भारत सरकार - रेल मंत्रालय  
अनुसंधान अभिकल्प और मानक संगठन  
लखनऊ - 226011  
Government of India - Ministry of Railways  
Research, Designs & Standards  
Organization, Lucknow - 226011

Sub: Issue of Altered Drawings No. SKEL-4893 Alt '1' for Modified Single Duct  
Leather Bellows for WAG9/WAP7 Locos pertaining to Modification Sheet No.  
RDSO/2009/ELRS/MS/0373 (Rev. '1') amendment '2' dt.15.04.2013.

Amendment-3

**Modification Sheet No. RDSO/2009/ELRS/MS/0373 ( Rev.'1') amendment-2 dated  
15.04.2013**

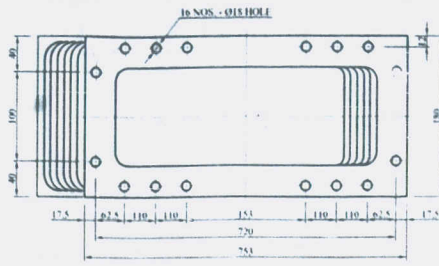
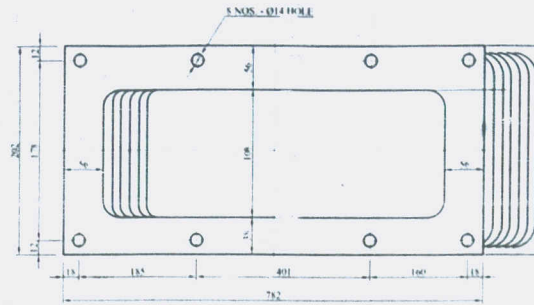
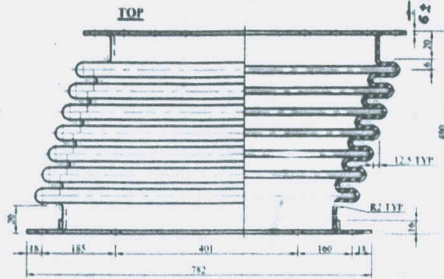
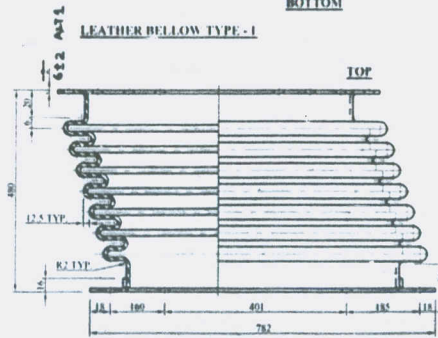
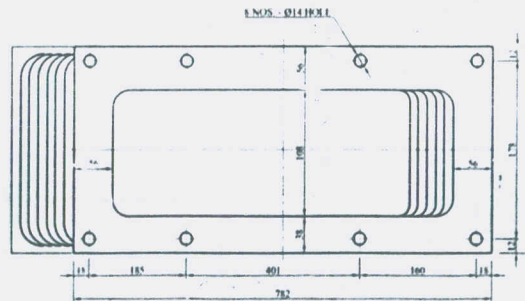
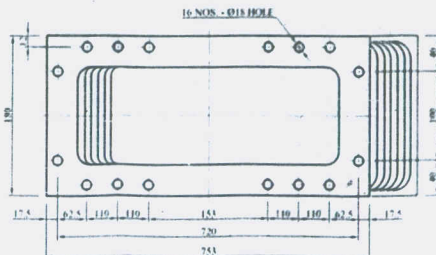
Vide letter quoted under ref. (ii) & (iii), firms reported problems in manufacturing of the subject item without manufacturing tolerances in some of the dimensions in existing drawings no. SKEL-4893 Alt '0'. RDSO studied the matter and necessary tolerances have been added. Revised drawing No. SKEL-4893 Alt '1' has been issued to overcome difficulties of manufacturing and inspection and the same is enclosed herewith along with amendment-3 of Modification Sheet No. RDSO/2009/ELRS/MS/0373 & 0374 (Rev. '1') amendment '2'.

STATUS	1.	dim 2 & note 1 modified & note 3 added	<i>[Signature]</i>	05.4.13
ALT.				
REF. NO.				
DESCRIPTION				
APPD. BY				
DATE

1. All dimensions are in mm. WITH TOLERANCE OF  $\pm 3$  mm.
2. Material :- TM Bellow Plate & Bellow Frame (Top & Bottom) Steel, IS : 2062.
3. **LEATHER BELLOW**
